March 9, 2012

FOOD STOREROOM BUILDING RENOVATIONS at ARUBA SURF CLUB

ADDENDUM NO. 3 (Post Bid VE)

C ARUBA SURF CLUB – WALK-IN COOLER/FREEZER FLOOR DETAIL
 FS1.0 | FS1.0 NOT TO SCALE

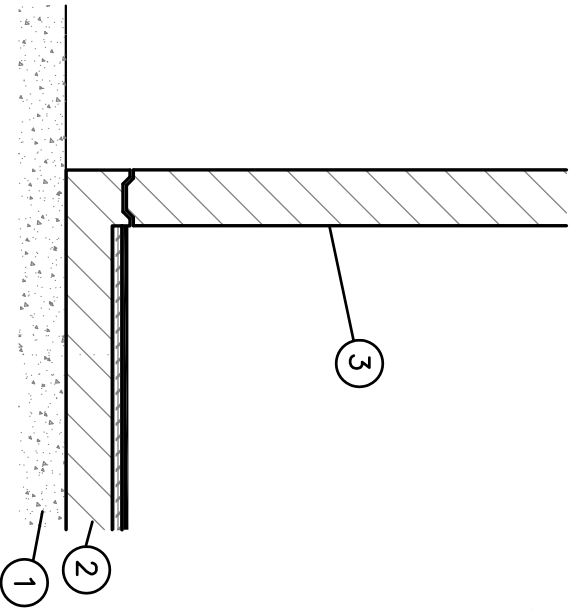
- Details A, B & C shall be revised to delete the concrete topping slab and 2" sand/mortar bed. See attached revised detail cooler-freezer floor detail.
- Change ceiling light fixture per the attached Project Requirement Revisions Item #3. Change the lighting fixture quantity and layout to match lighting layout on sheet E3.0
- Shelving in the in the Cooler, Freezer, Dry Storage A & B and Beverage Storage shall be in the quantities and types as indicated on the attached Shelving Requirements spreadsheet and Project Requirement Revisions Item #5. Coordinate layout with the Owner's representative in the field

1. Exposed floor inside cooler and freezer room shall be foamed-in-place 3 mm (1/8-inch) thick aluminum diamond treadplate reinforced with 20 mm (3/4-inch) marine plywood. Floor at exterior door entrance shall include an interior ramp with reinforced aluminum diamond treadplate.

A2.0
(VE ADJUSTED DRAWINGS)

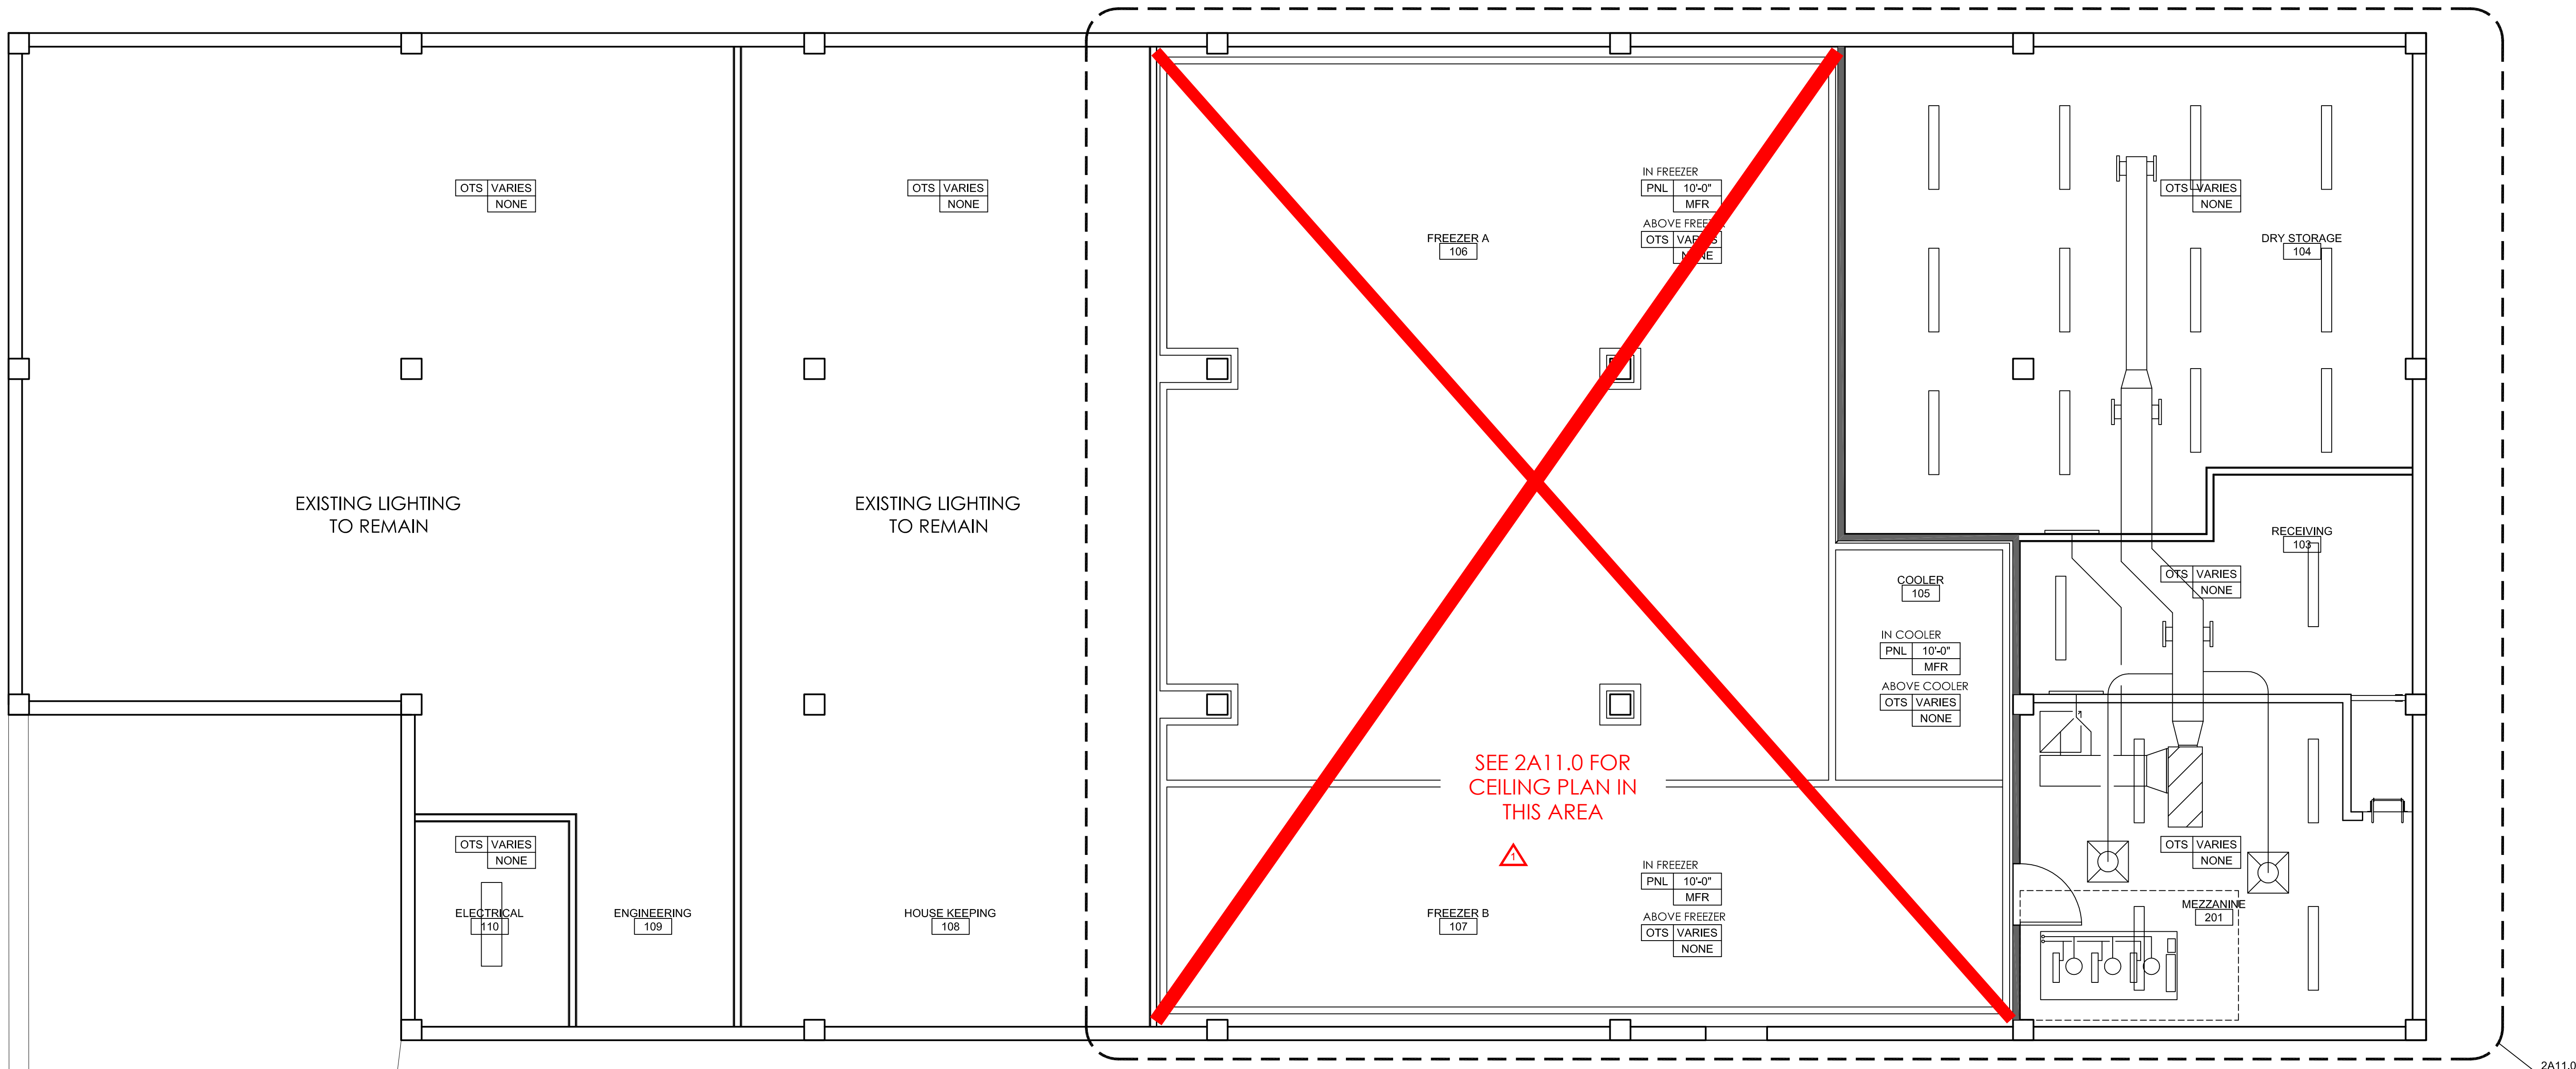
Sheet A2.0 (Base Bid) – The following are VE modifications to the floor plan. See revised A2.0 sheet.

- Change wall between Engineering 109 and Housekeeping 108 from studs and gypsum board to full height chain link fencing. Fencing can be salvaged/reused from existing demolished fencing.

- Delete wall between Housekeeping 108 and Freezer 106 & Cooler 107.
- Delete full height wall between Freezer 106 and Dry Storage B and Cooler 107 and Beverage Storage 102. Provide suspended wall per 12A2.0.

- Delete mezzanine, mezzanine access ladder. Move all A/C and Refrigeration equipment to the roof.
- Delete painting for existing walls, columns and doors. Paint only new wall and new HM doors and frames and other metal items in order to protect from the environment.

- Delete concrete topping slab, sand underlayment & sealers in Cooler 107 & Freezer 106. Delete concrete ramp into cooler/freezer. Cooler/Freezer manufacturer is to provide a ramp with reinforced aluminum diamond treadplate.

- Delete hand sink/eyewash station. Provide a single hose bib at the exterior of the building.
- Doors 106-1, 108-2 & 109-2 are labeled existing to remain. There is no work at these doors other than to lock/secure in the closed position.

- Change door 110-1 from a solid HM door to a fully louvered HM Door.

A11.0

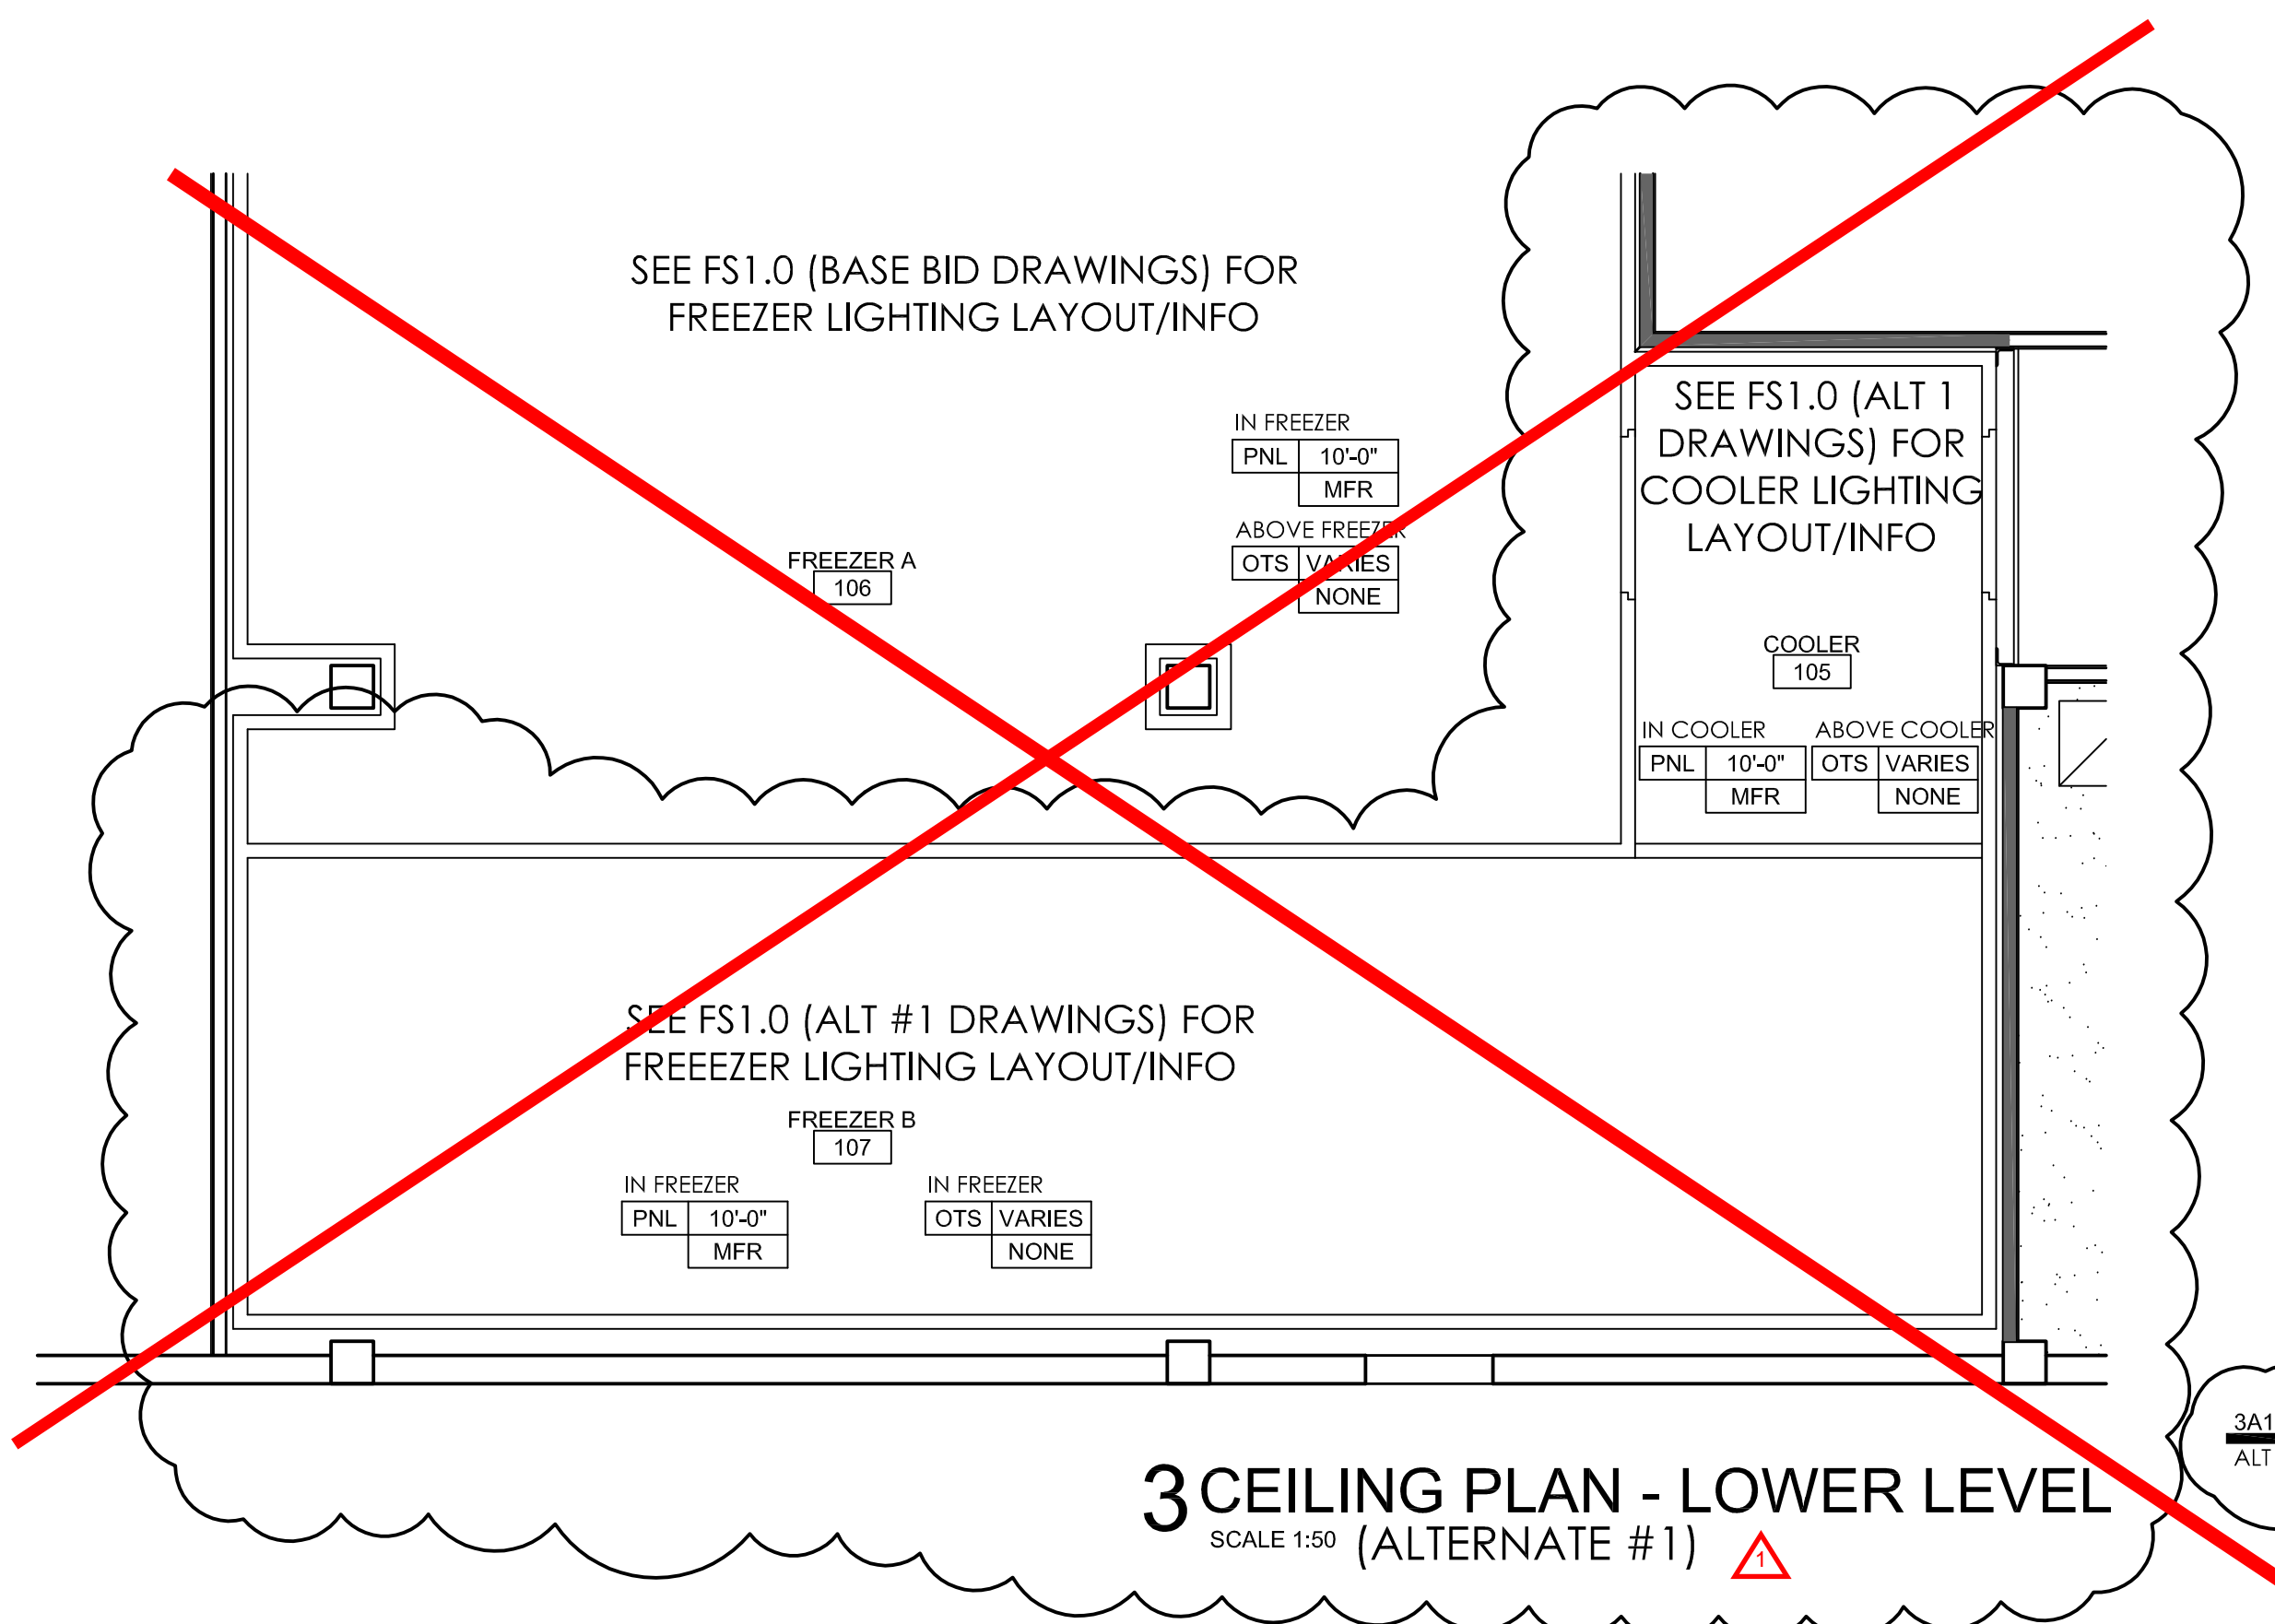
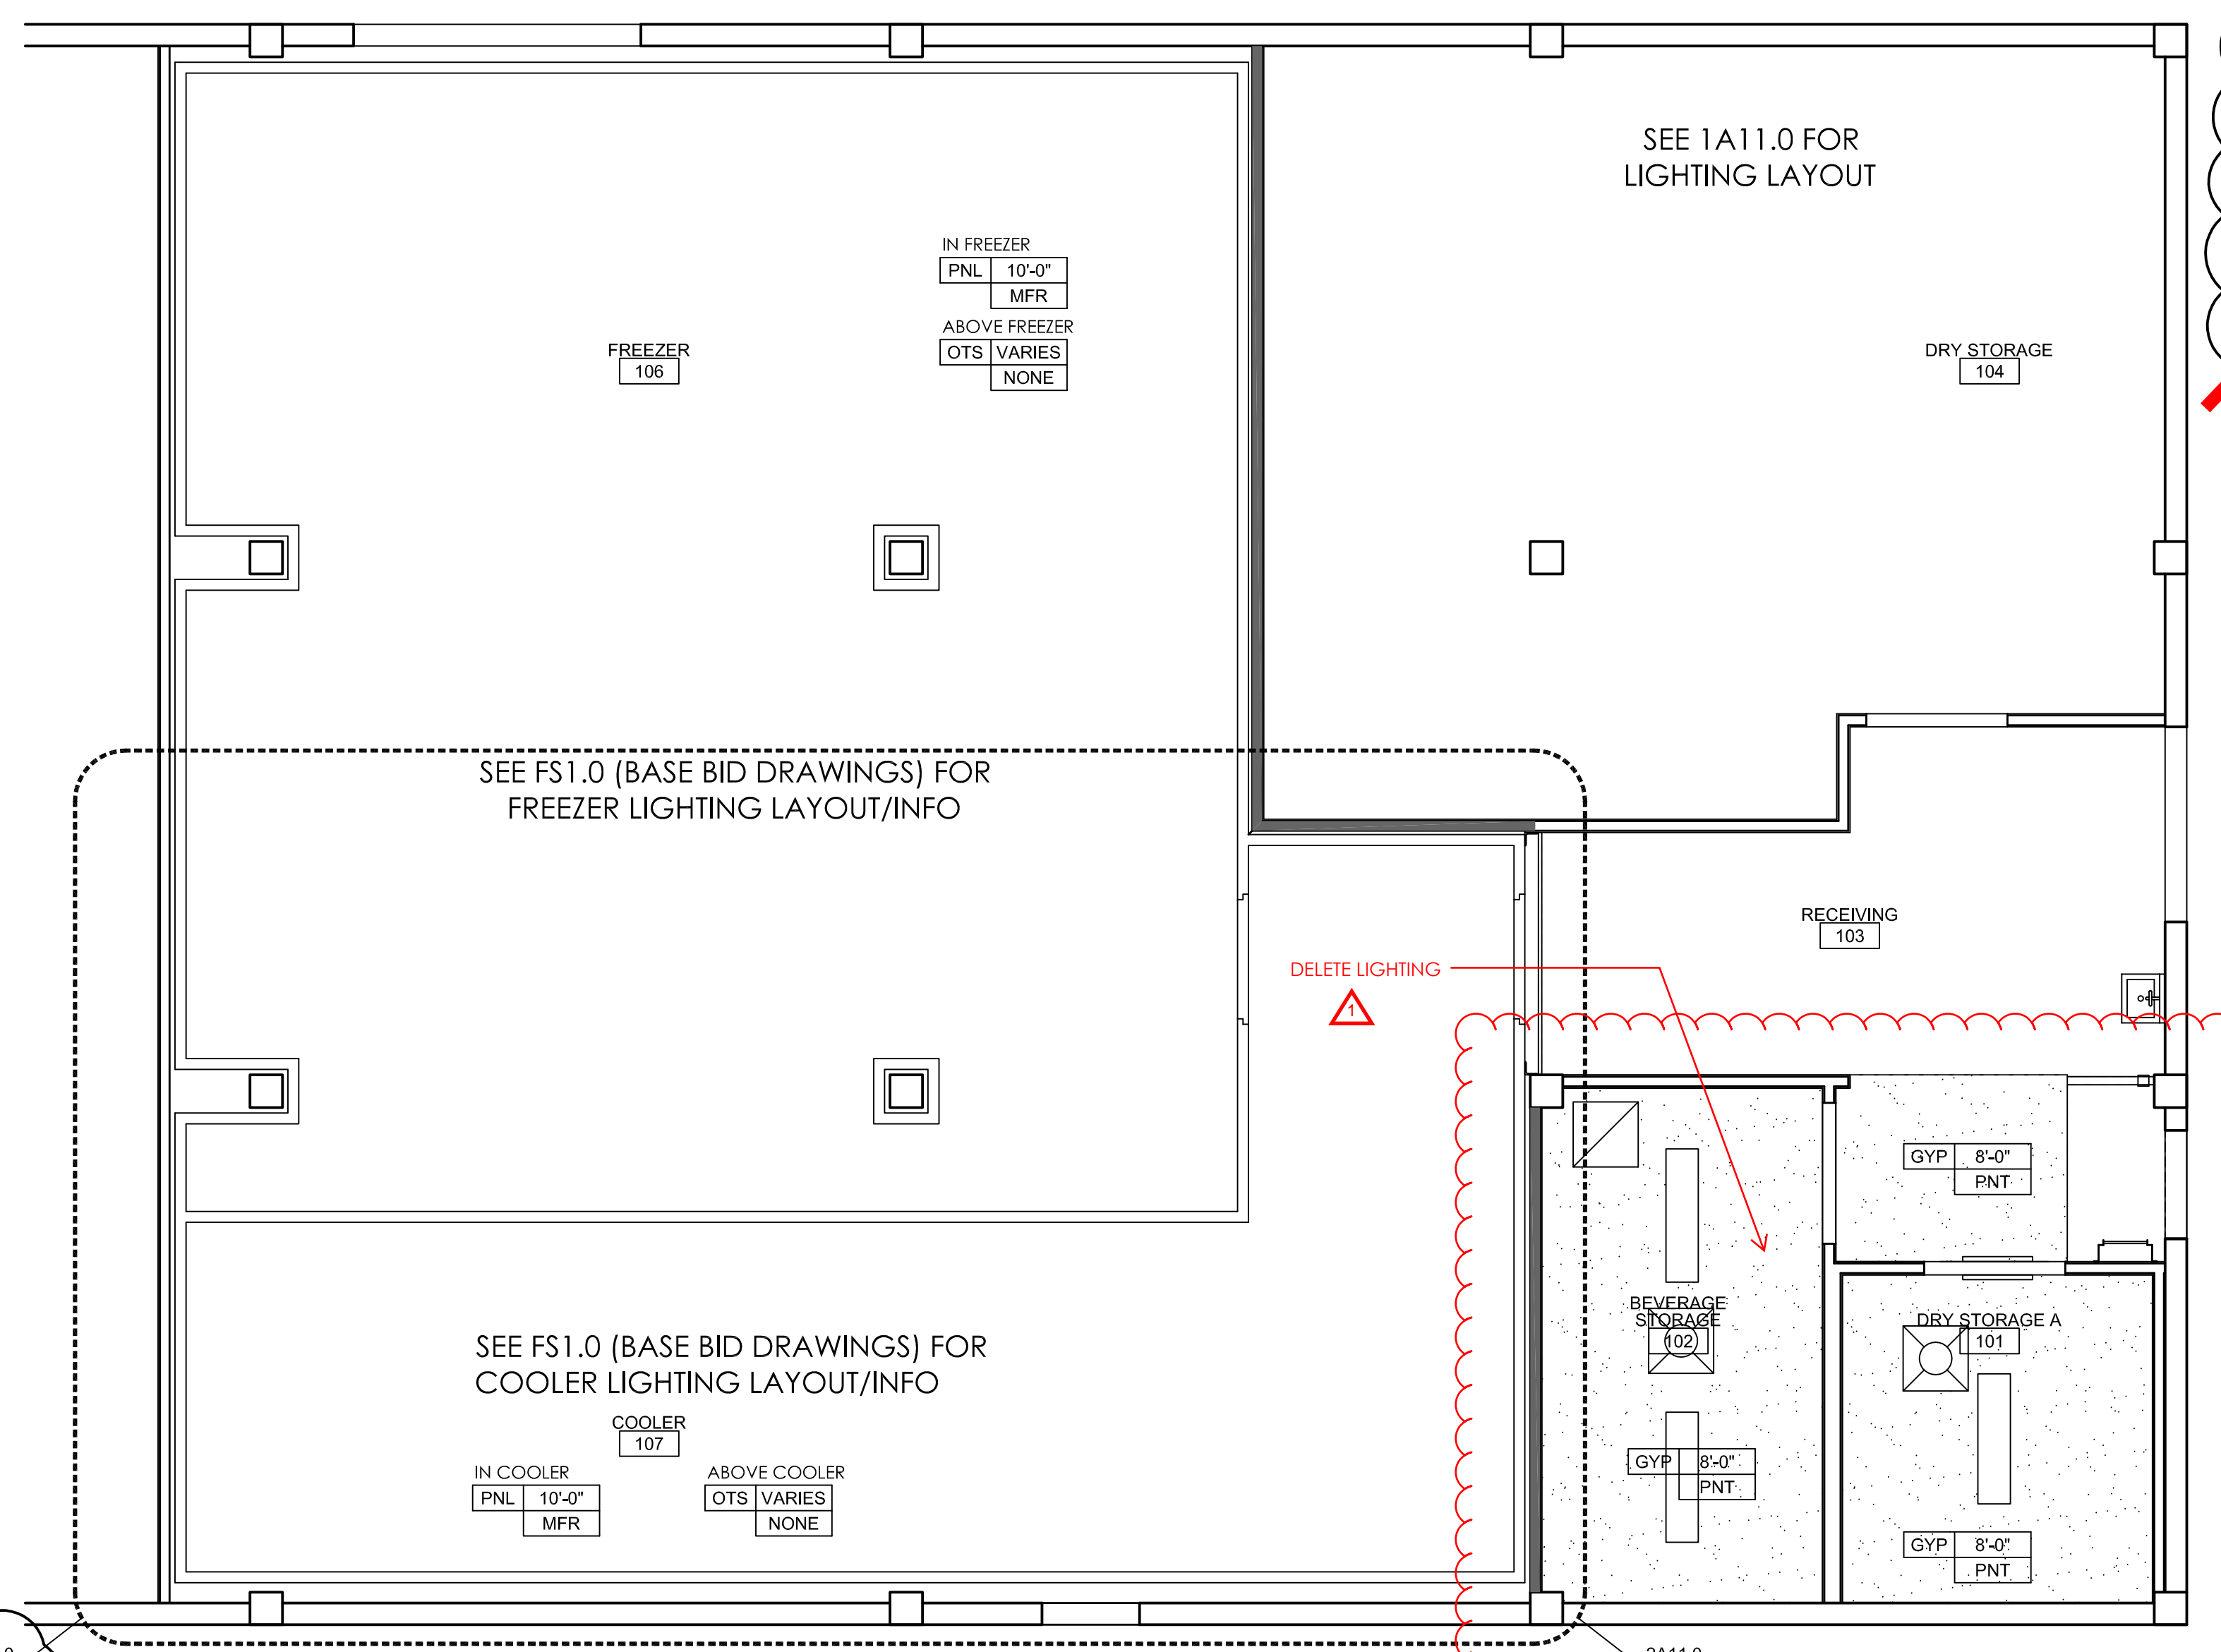
Sheet A11.0 - The following are VE modifications to the floor plan. See revised A11.0 sheet.

- Delete gypsum board ceilings in Beverage Storage 102 & Dry Storage A 101.
- Delete all work and drawings regarding Alternate #1.
